Figure 3 - Clearance Requirement Around Fuel Storage Tank.

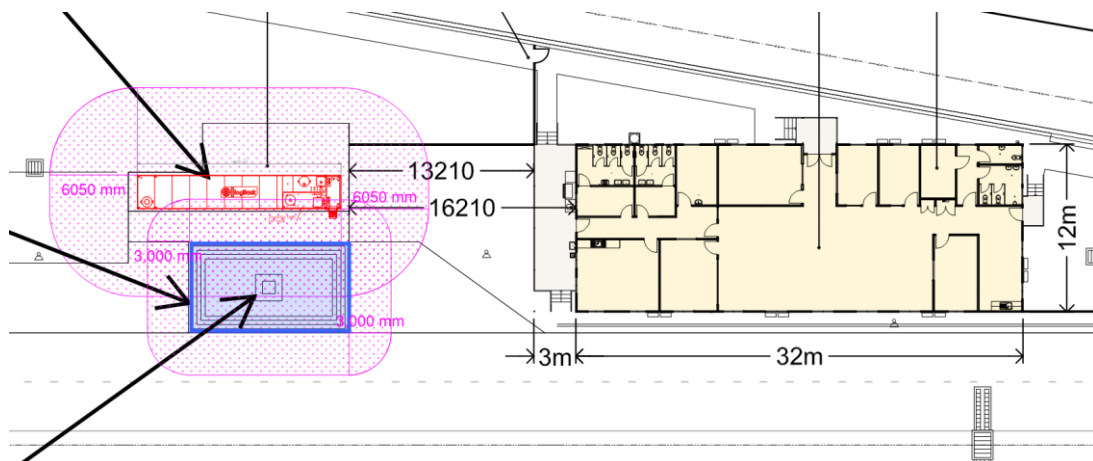
The separation distance of a tank containing C1 Combustible liquid from an office building or other habitable onsite building (in accordance with AS1940 Table 5.3) is determined by AS1940 Table 5.4, with the maximum separation distance to an onsite protected place not requiring to be greater than 7.5m (irrespective of storage volume).

AS1940 Table 5.4 provides the separation distances of storage tanks from protected places in 1m increments (15m with increments there after extending to every 5m). This separation distance is provided with respect to the volume of liquid stored. Where the liquid storage volume is between two values presented within Table 5.4, linear interpolation is used to determine the separation distance. For a tank storage volume of 71,598L (71.6m³) the separation distance is 6.05m Refer Figure 3 for visual representation of the clearance requirement.

The requirements presented in this assessment comprise an overview of the minimum requirements in accordance with the Australian Standard AS1940-2017 and have been prepared using the information available at the time of assessment. With the tank located in its current position, the minimum separation distances required by AS1940 have been achieved.
